Subject: UniStar Nuclear Energy, NRC Docket No. 52-016  
Response to Request for Additional Information for the  
Calvert Cliffs Nuclear Power Plant, Unit 3,  
RAI No. 155, Emergency Planning

**Response to NRC Request for Additional Information  
RAI No. 155, Questions 13.03-7 through 13.03-21,  
Emergency Planning,  
Calvert Cliffs Nuclear Power Plant, Unit 3**

**RAI No. 155**

COLA Part 5, Emergency Plan, Part II, Figure A-2 will be revised as follows in a future COLA revision.

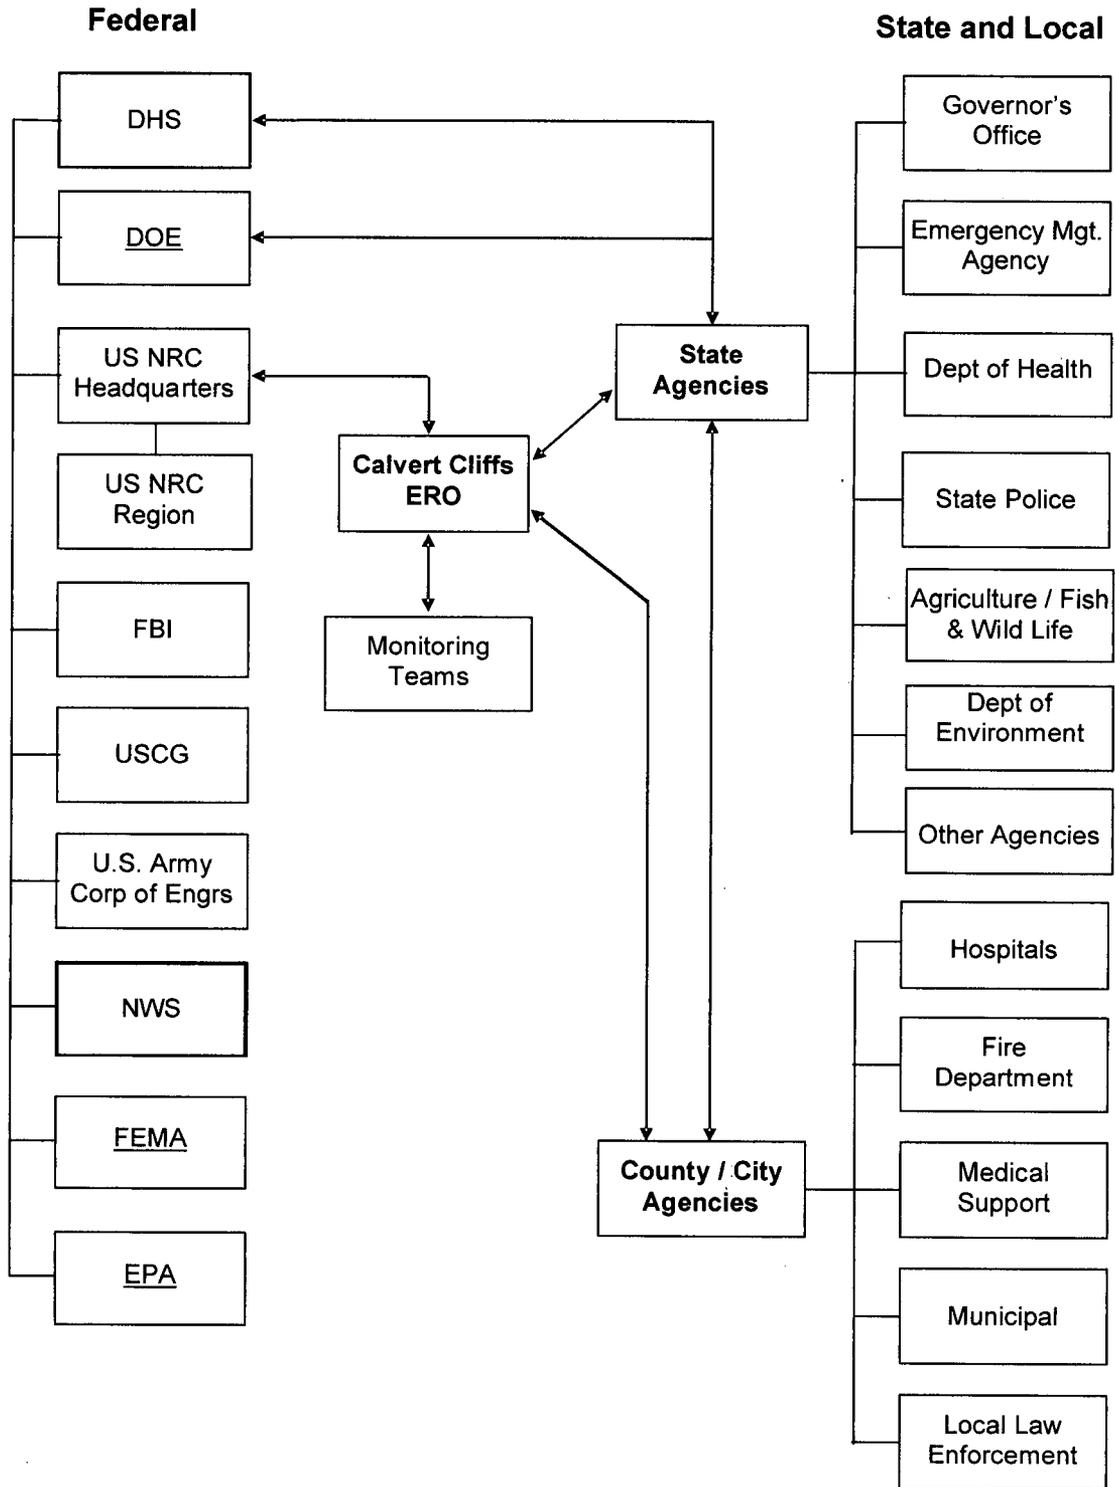
1. Provide organizations (i.e. Federal Emergency Management Agency (FEMA), Environmental Protection Agency (EPA), Federal Radiological Preparedness Coordinating Committee (FRPCC), Radiation Emergency Assistance Center/Training Site (REAC/TS) that were not identified in the block diagrams.
2. Identify in the diagram where the U.S. Department of Energy (DOE) assistance is requested.

- B.1 Emergency Plan, Figure A-2 will be revised to include blocks for FEMA and EPA. FRPCC and REAC/TC are sub-groups of organizations already listed in Figure A-2.

- B.2 Emergency Plan, Figure A-2 will be revised to include a block for DOE.
- C. COLA Part 10, Table 2.3-1, will be supplemented with an ITAAC to acquire the final and complete Letters of Agreement (LOA) developed between Federal, State, and local agencies and other support organizations having an emergency response role within the Emergency Planning Zones. The LOA will identify the emergency measures to be provided and the mutually acceptable criteria for their implementation, and will specify the arrangements for exchange of information.

Figure B-1c: Emergency Offsite Organization

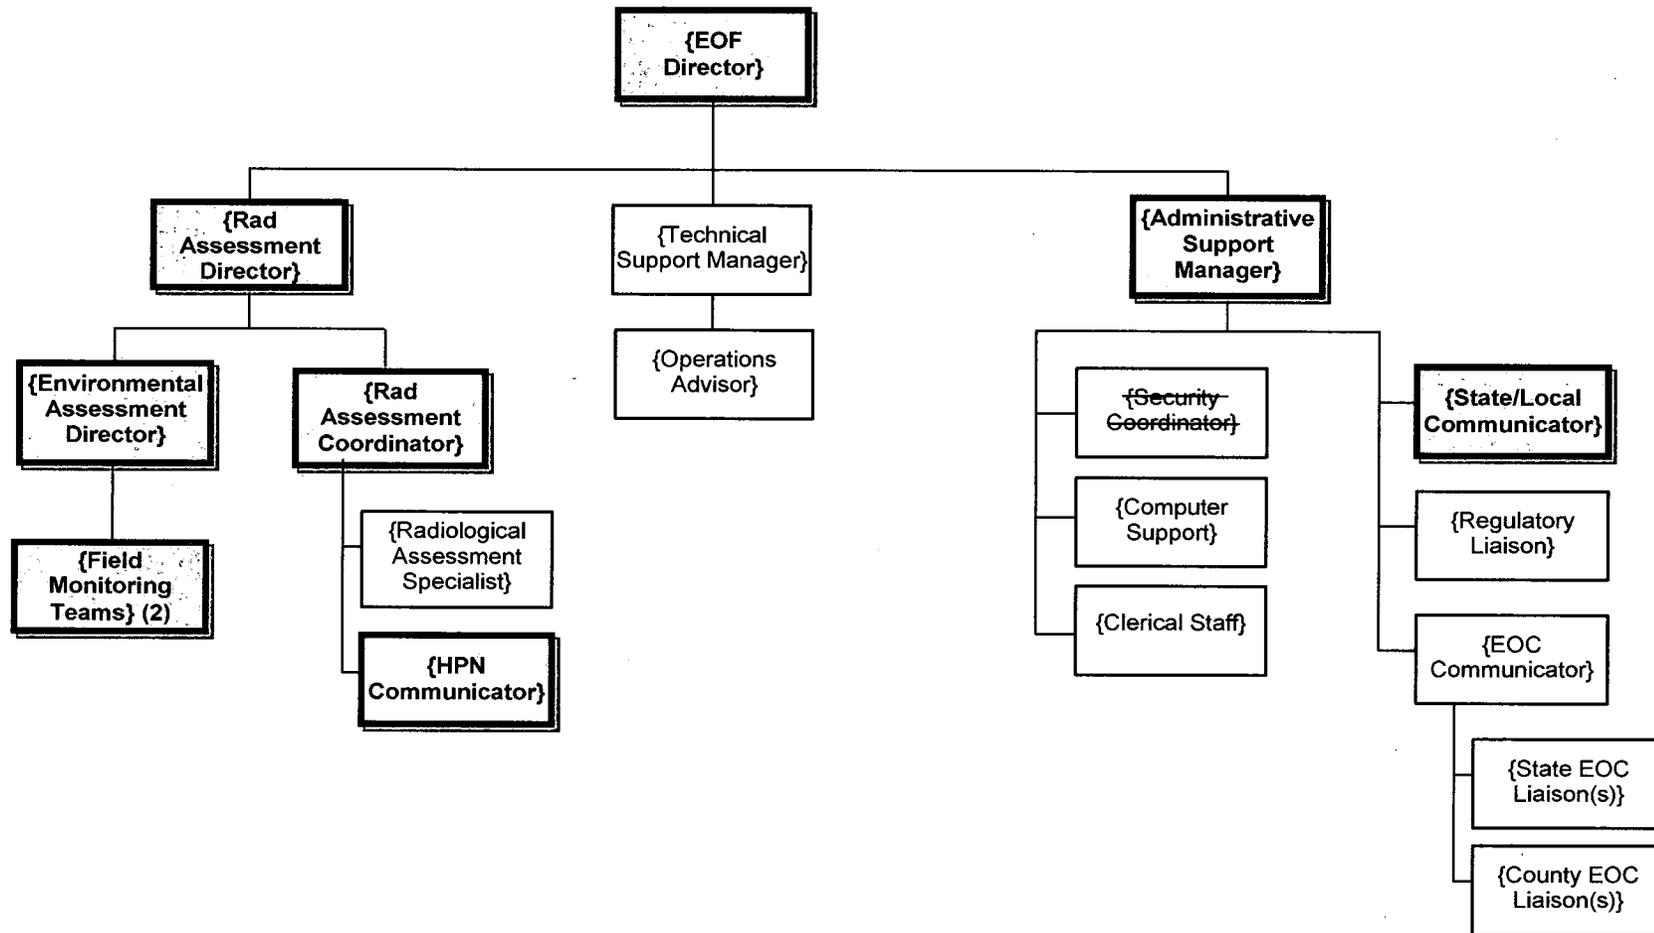
- Address field monitoring teams and clerical staff shown in Figure B-1c in Section B.5.b.
- Address the Administrative Support Manager, clerical staff and facility support staff shown in Figure B-1d in Section B.5.c.

- Figure B-1c includes positions not clearly listed in Table B-1b (Field Monitoring Teams, Security Coordinator).
- Figure B-1d includes positions not clearly listed in Table B-1b (Administrative Support Manager).

A.3 A discussion concerning Field Monitoring Teams will be added to Section B.5.b.

A.12 The Figure B-1c Field Monitoring Teams are provided in Table B-1b, Section 4, as Offsite Monitoring Team Personnel. No inconsistencies could be identified with regard to the information contained in the figure and the table.

The Security Coordinator position is only in the TSC. The Security Coordinator position will be removed from Figure B-1c.

Figure B-1d: Emergency Public Information Organization

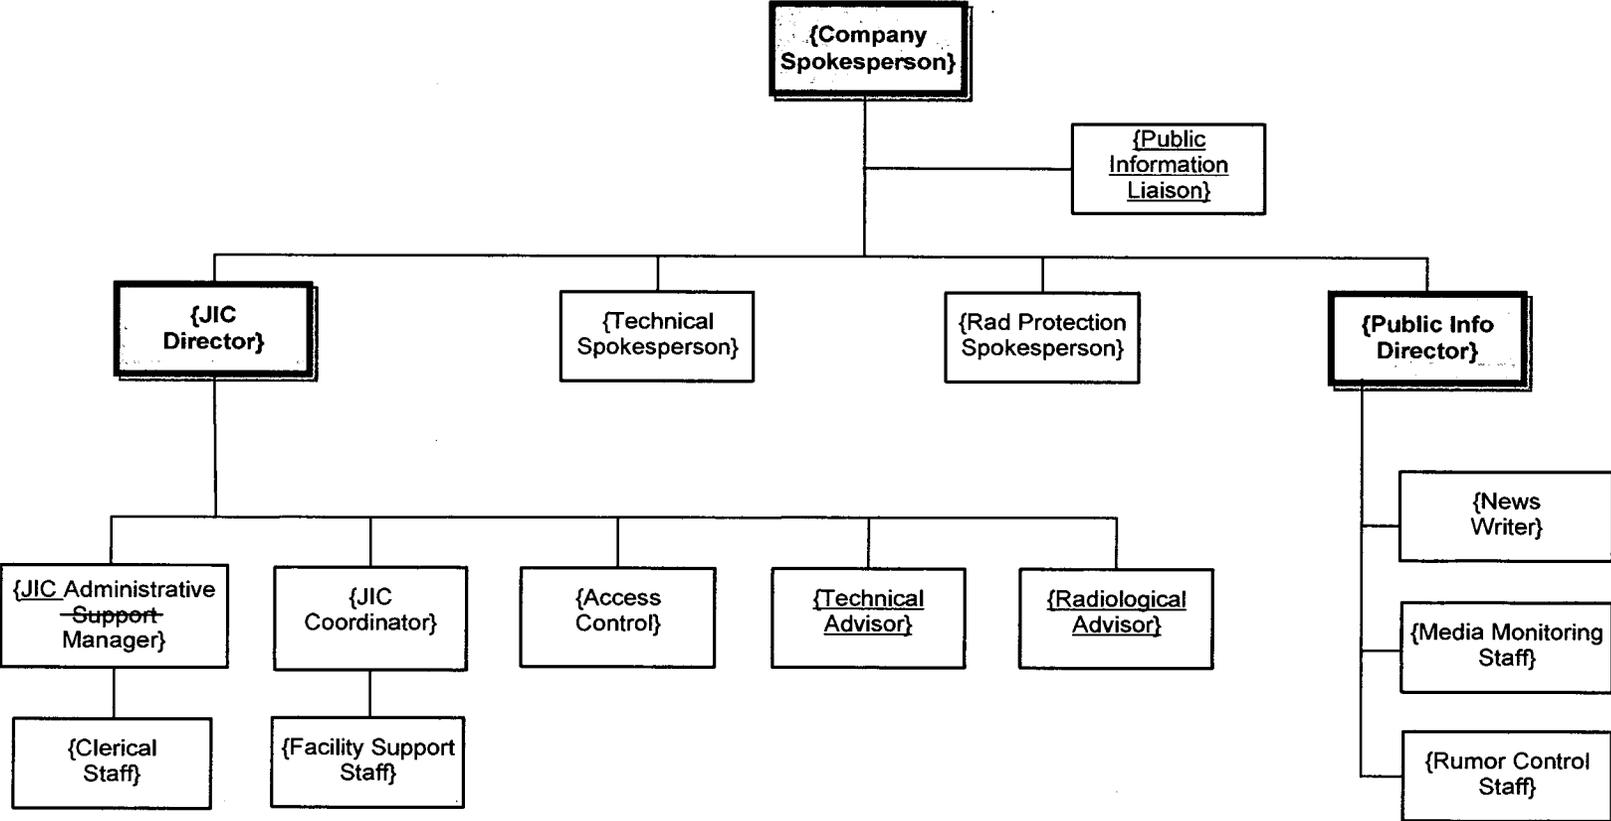
- Include the information from Section B.5.c, "JIC [Joint Information Center] Administrative Manager;" C.7, "Public Information Liaison;" C.10, "Technical Advisor;" and C.11, "Radiological Advisor," in Figure B-1d.

- A.4 Section B.5.c.7 describes the duties of the JIC Administrative Manager, which is the JIC Administrative Support Manager in Figure B-1d. The discrepancy in the Figure B-1d position title will be corrected.

Organizational boxes for Public Information Liaison, Technical Advisor, and Radiological Advisor will be added to Figure B-1d.

A.13 The Figure B-1d JIC Administrative Support Manager position box is the Table B-1b JIC Administrative Manager. The discrepancy in the position title will be corrected.
